Delegated Report		Analysis sheet		Expiry Date:	28/01/2025
		N/A		Consultation Expiry Date:	06/01/2025
Officer			Application Number(s)		
Ewan Campbell			2024/5410/P		
Application Address			Drawing Numbers		
72 Camden Mews London NW1 9BX			Please refer to draft decision notice		
PO 3/4	Area Team Signature	C&UD	Authorised Officer Signature		
Proposal(s)					
Erection of ground floor front extension with new staircase from ground to 1st and 1st to 2nd floor, two new terraces at 1st and 2nd floors, new metal gate, infill of existing rear conservatory at first floor, new side balcony; erection of setback roof extension with 3 solar panels and air source heat pump; replacement of windows and doors.					
Recommendation(s):		Refuse Planning Permission			
Application Type:		Householder application			
Conditions or Reasons for Refusal:		Refer to Draft Decision Notice			
Informatives:					
Consultations					
		No. of responses	08	No. of objections	03

1. PROPOSAL

- Erection of single storey ground floor front extension with new staircase from ground to 1st and 1st to 2nd floor,
- Two new terraces at 1st and 2nd floors,
- New metal gate to front boundary;
- Infill of existing rear conservatory

Existing and proposed sections

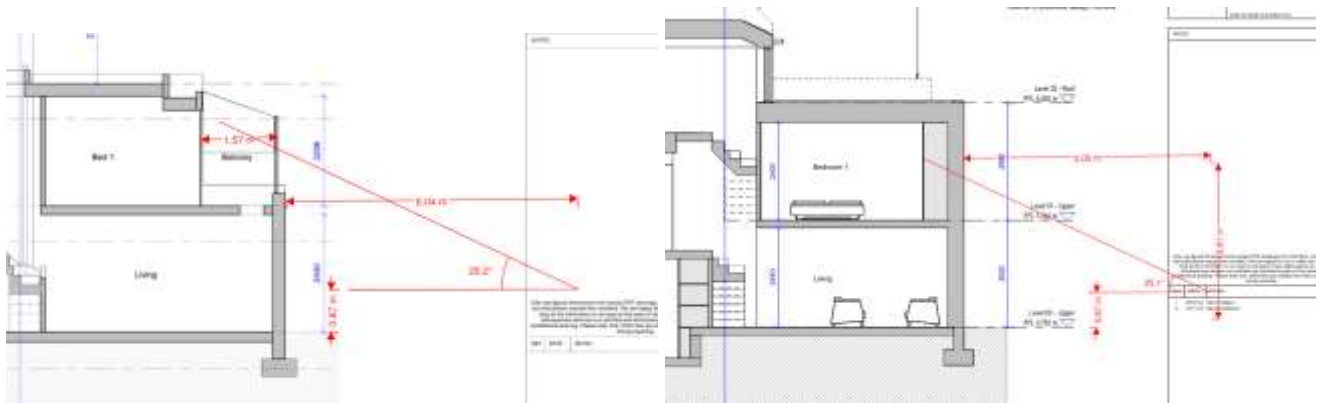
- 3.2.2. In terms of daylight/sunlight, the mews contains close relationships which rely on lower daylight/sunlight scores and ultimately remains part of its character. However it is clear that the only property affected is 12 North Villas to the rear. From measuring the floor plans the rear elevation it is approximately 6.0m away. The rear extension increases the height at the boundary by roughly 0.8m and increases the depth of the extension by 1.6m meaning the overall height and depth has increased in this location. In terms of daylight/sunlight no

assessment has been provided to support the scheme. Therefore the Council has conducted its own using the scaled drawings provided. As you can see below a 25 degree line is measured in the same position on the existing and proposed sections from where the rear windows of 12 North Villas are located. As stated, due to the close relationships the windows to the rear of 12 North Villas already fail the 25 degree line. There is also a photo of the existing situation showing the enclosed balcony and relative height.

- 3.2.3. This indicates that there will be a slight increase in height and a small increase in terms of impact to the daylight/sunlight scores. However the increase is small and is not considered to harmfully compound the relationship that exists currently. Overall, whilst no daylight/sunlight assessment has been submitted, the Council asserts that the impact is of an acceptable level.
